Access Compliance Report Public Rights-of-Way (Pedestrian Signals)

Main Street: **ANTONIO_PKWY** Cross Street: **SWEETWATER** Location: **N**

ADA ID: **SGRK211028172201** Signal Type: **One Push Button-APS** Overall Compliance: **No** Severity Scores: **BTN 1: 25** **BTN 2: N/A** **No BTN: N/A**

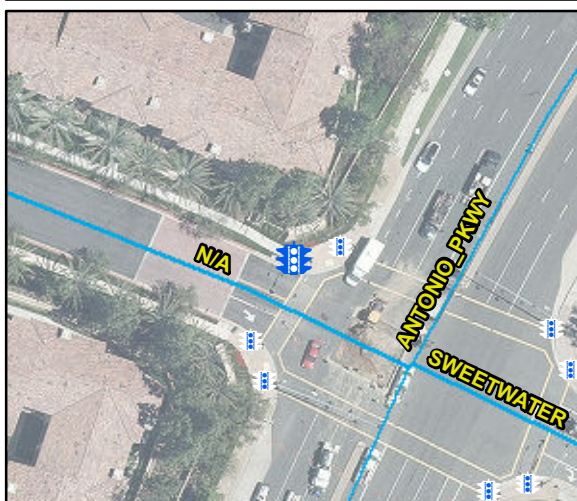
OC Std/PROW: **R404.2, R404.3**

Possible Solutions: Remove and Replace Clear Space.
